PUBLIC HEARING/WORKING SESSION MEMORANDUM

PETITION #268-19

58 Cross St./1089 Washington St.

Re: Special Permit – 1089 Washington Street

Existing Site Plan

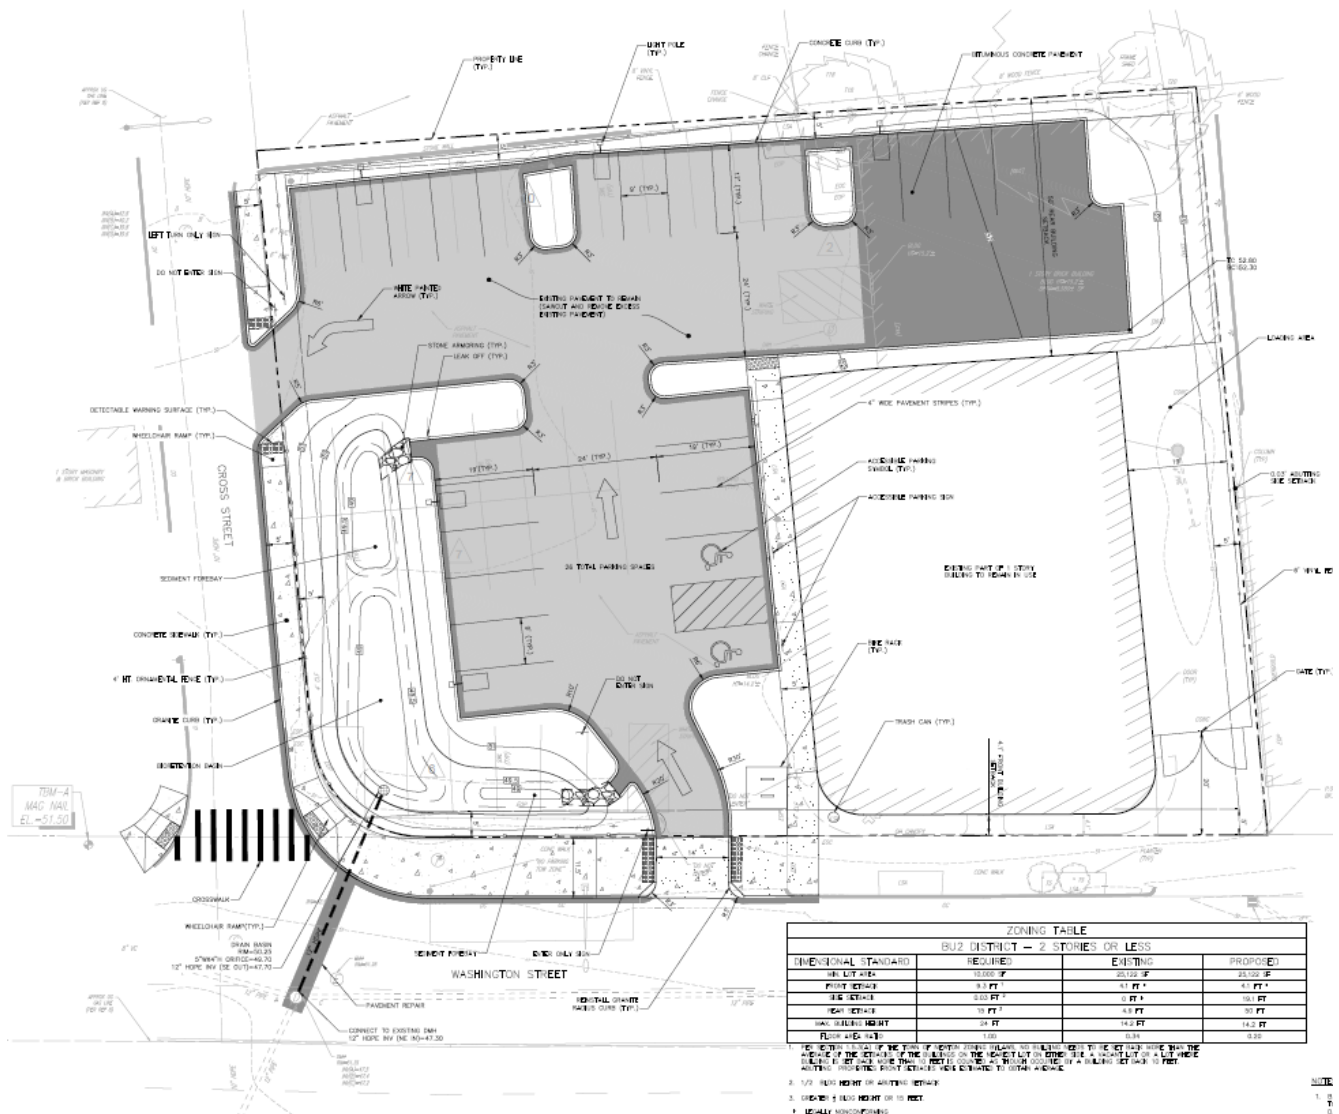
The petitioner originally proposed to keep the existing 8,585 square foot building with the marijuana retailer occupying 4,985 square feet and the rest of the building as vacant space to comply with the City's marijuana ordinance that limits marijuana retailers to 5,000 square feet of space for their operations. After neighbors expressed concern and a desire to see the rear portion of the building demolished, the Petitioner submitted plans that show the rear of the building demolished. The petitioner stated after demolition, the remaining space for the marijuana retailer is decreasing to 4,973 square feet. In place of the rear building, the petitioner is relocating parking there to accommodate a rain garden at the Washington Street and Cross Street corner of the site. The proposed rain garden satisfies recommendations from the Engineering

Department outlined in the Engineering Memorandum (**Attachment A**). Members of the Land Use Committee also questioned whether there was a better configuration for the ADA stalls that would prevent customers who need the ADA stalls from having to cross the Washington Street entrance to the site. The revised plans show the ADA stalls along the western side of the building, which allows customers that will utilize the ADA stalls safe access to the building.

Proposed Site Plan

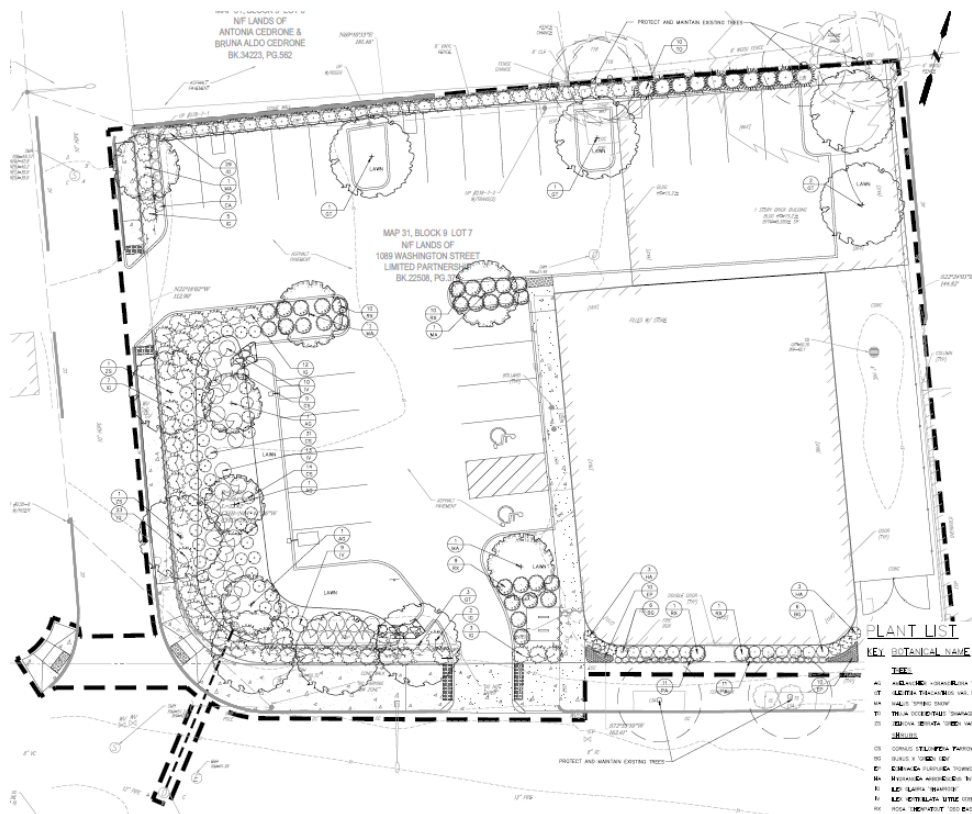
Additional improvements to the site include the reduced curb cut on Washington Street from 23 feet to 14 feet. The Washington Street curb cut is shown shifted to the west to allow for the site improvements.

The petitioners are replacing the sidewalks and pedestrian ramps on Cross Street and Washington Street as well as installing a sidewalk on Cross Street, parallel to Washington Street.
